# UNITED STATES PATENT AND TRADEMARK OFFICE

10/550,991

<b>Office Action Summary</b>	<b>Application No.</b> 10/550,991	<b>Applicant(s)</b> FOTINOS ET AL.	
	<b>Examiner</b> ERNST V. ARNOLD	<b>Art Unit</b> 1616

### **DETAILED ACTION**

Lee et al. disclose in Figures 1-4, reproduced below:

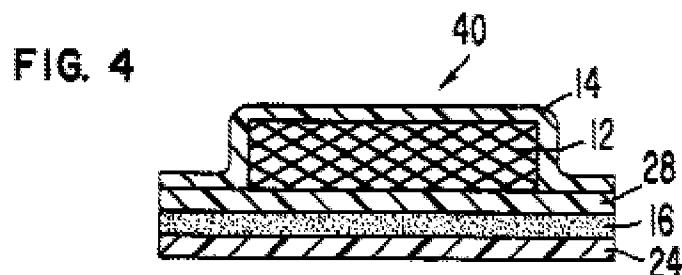
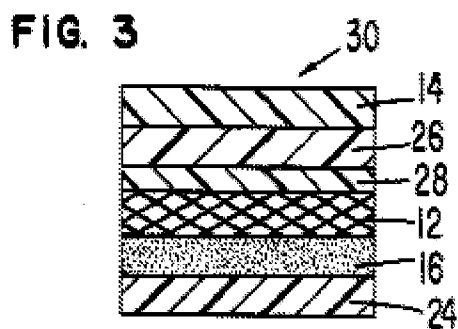
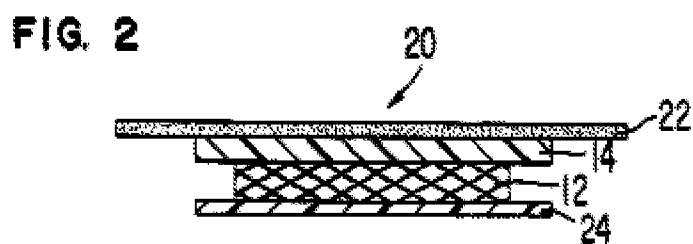
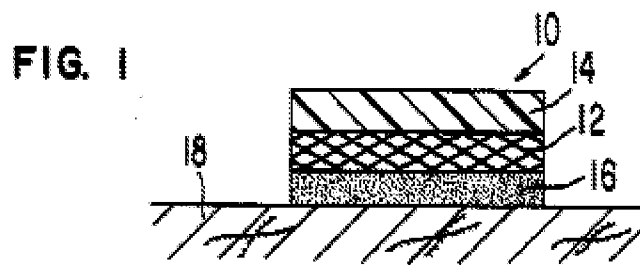
a transdermal drug delivery device comprising a reservoir with an active agent and methods of treating neurogenic bladder disorders (Abstract and claims 1-28). As is

clearly shown above in the Figures, for example Figure 2, device 20 contains an active ingredient reservoir 12. A backing layer 14 and adhesive overlay 22 maintain the device to the skin. A strippable release layer 24 is removed just prior to use (column 5, lines 24-49). Other materials are contemplated in the construction of the device (column 7, lines 15-33). Discs were cut of the laminate (column 9, lines 20-23).

So, in other words, a method of holding an active-agent containing composition (oxybutynin) comprising, providing a support substrate (cloth backing) with one side in contact with a pattern adhesive, it has the pattern of the cloth backing, (column 9, lines 45-59), pouring the active agent solution on the a sheet of fluorocarbon diacrylate/polyester sheet (support substrate treated with a fluorochemical) and allowing it to dry before pressing it between two sheets of release liner (since it is a release liner it is removably attached otherwise it wouldn't release); attaching the resulting film to a flexible cloth backing (support substrate) and segmenting the final support substrate into an array of discrete film segments; into discs. It is the Examiner's position that the

adhesive has a single pattern. So, by making the device of Lee, it inherently performs the method of holding an active agent containing composition. In this way, claims 51, 56, 62, 121 and 122 are anticipated. In the absence of evidence to the contrary, the steps are performed in a continuous process, each disc contains a uniform amount of active agent thus anticipating instant claims 59 and 60.

Applicant asserts that Lee does not disclose segmenting a layer of film attached to a support substrate into an array of discrete film segments attached to the support substrate and directed the Examiner to Figures 1 and 2. Respectfully, the Examiner cannot agree. The claim language is not so specific to limit the "invention" to what is shown in figures 1 and 2. In claim 51:

All that is required is that the film attached to the support substrate is segmented into an array of discrete film segments attached to the support substrate. The multiple discs of Lee et al. are an array of discrete film segments attached to the support substrate. In support of the Examiner’s position is Applicant’s own disclosure which clearly states on page 12, lines 10-11: “...the method further includes a step of cutting
